**APPENDIX C**  
**AREA WALK-BY CHECKLISTS (AWCs)**

**Area Walk-By Checklist (AWC)**

Room 105 Floor El. 545 Bldg. AUXB

**Photo 1**  
**General View of Room 105 Area**

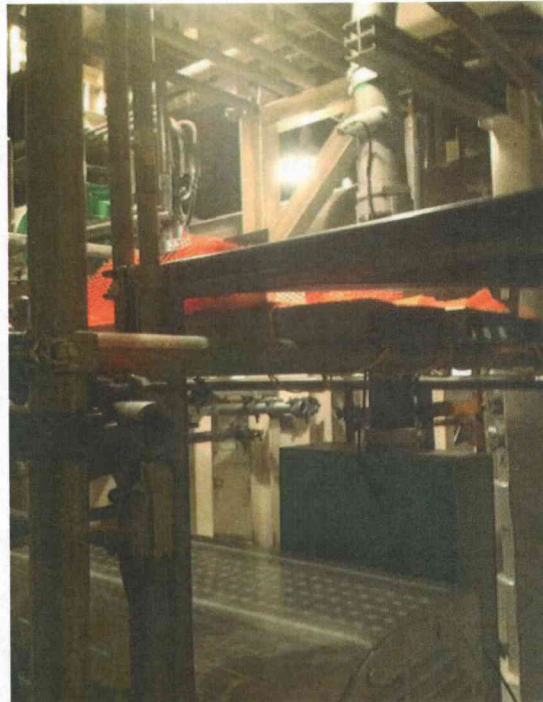
*Anchorage for cover plate of E31-4 does not have nuts, see Photo 2. Concern has been judged not to represent an adverse condition regarding the component's seismic performance.*

*Temporary scaffolding in area appears to be adequately restrained. See Photo 3.*

**Photo 2**  
**Crack in Masonry Wall**

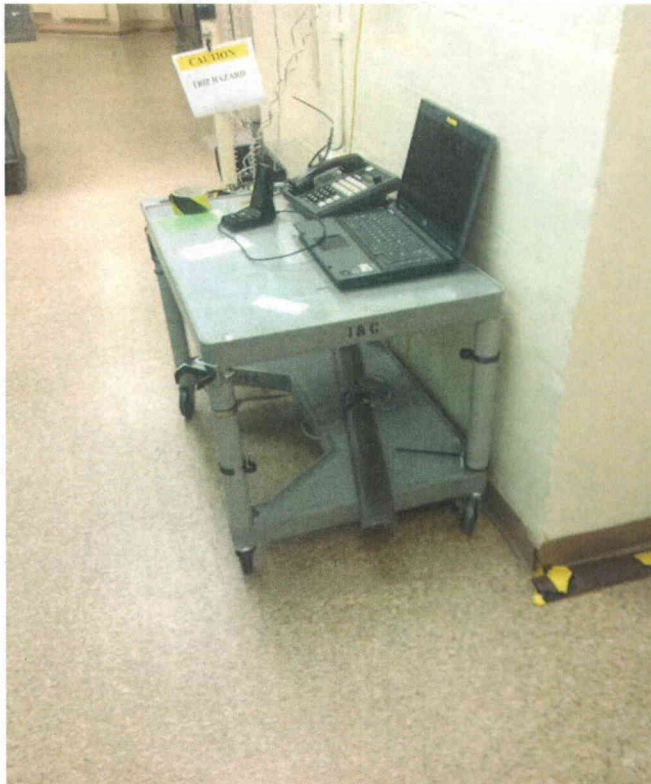
*Ceiling panels anchored, see Photo 1.  
Masonry walls in area. Verify seismic adequacy of walls  
Walls identified as 5107, 5127, 5287, 5297, 5347, 5357, 5367.  
All walls have been seismically analyzed per NRC IE Bulletin 80-11 (Ref. VBW29-B001-145, Rev 13, VBW29-B001-146, Rev 8, VBW31-B001-159, Rev 9, VBW31-B001-160, Rev 3, VBW31-B001-161, Rev 4, VBW31-B001-162, Rev 1, VBW31-B001-163, Rev 2.*
